Project	IEEE 802.16 Broadband Wireless Access Working Group < http://ieee802.org/16 >		
Title	16h frame structure for compatibility with 802.16e SS		
Date Submitted	2008-01-15		
Source(s)	Mariana Goldhamer Alvarion ltd. 21A, Ha Barzel Street Tel Aviv	E-mail:	mariana.goldhamer@alvarion.com
Re:	LB 29		
Abstract			
Purpose	[Description of what <i>specific</i> action is requested of the 802.16 Working Group or subgroup.]		
Notice	<i>This document does not represent the agreed views of the IEEE 802.16 Working Group or any of its subgroups. It represents only the views of the participants listed in the "Source(s)" field above. It is offered as a basis for discussion. It is not binding on the contributor(s), who reserve(s) the right to add, amend or withdraw material contained herein.</i>		
Release	The contributor grants a free, irrevocable license to the IEEE to incorporate material contained in this contribution, and any modifications thereof, in the creation of an IEEE Standards publication; to copyright in the IEEE's name any IEEE Standards publication even though it may include portions of this contribution; and at the IEEE's sole discretion to permit others to reproduce in whole or

Fig. 1 Proposed CX Frame structure

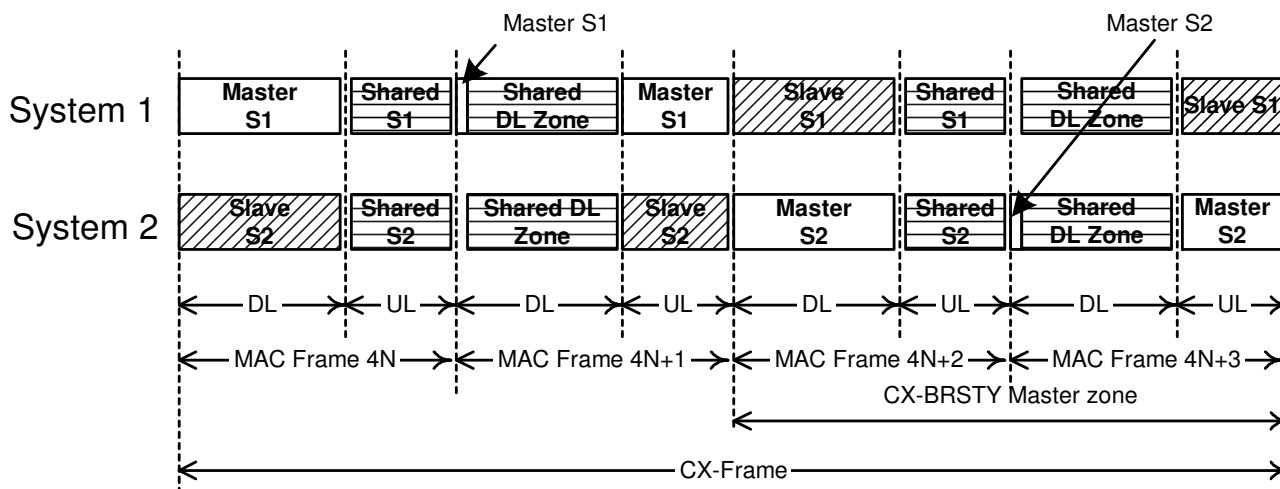
In the OFDM PHY the UL MAP relevance is for the existing frame and the next Frame, while in the OFDMA PHY the UL MAP relevance is only for the next Frame.

The existing CX-Frame approach assumes that the UL MAP relevance is for the same frame.

Fig. 1 presents the proposed solution, to replace the solution in P802.16h/D3, fig. h48.

The main scope was to keep the 4 Frames structure of the CX-Frame. Due to the fact that every OFDMA subscriber needs to be active during two frames, namely the one in which the MAP is transmitted and the one in which the UL activity takes place, it is possible to support only two systems on a channel. The second Frame

shall start in the legacy mode, using a preamble, FCH and MAP.

System 1 uses the first two DL sub-frames in the cycle as follows:

- Frame $4N$, DL is a full Master DL sub-frame
- Frame $4N+1$ is used as DL Master only to transmit the legacy Preamble, FCH and MAPs. For this activity should be reserved four symbols. The Master sub-frame is followed by a Shared downlink sub-frame, to be scheduled as one of the existing Zones by the CX-DL-MAP having extended relevance.

System 2, working in parallel with system 1:

- Frame $4N$, DL is a Slave Frame
- Frame $4N+1$ starts the transmission as a Shared downlink sub-frame, to be scheduled as one of the existing Zones by the CX-DL-MAP having extended relevance.

System 1 uses the first two UL sub-frames in the cycle as follows:

- Frame $4N$, UL is a Shared sub-frame The UL activity during the Shared UL sub-frame is scheduled by using the CX-DL-MAP having extended relevance.
- Frame $4N+1$ is used as UL Master.

System 2, working in parallel with system 1:

- Frame $4N$, UL is a Shared sub-frame. The UL activity during the Shared UL sub-frame is scheduled by using the CX-DL-MAP having extended relevance.
- Frame $4N+1$ is used as UL Master.
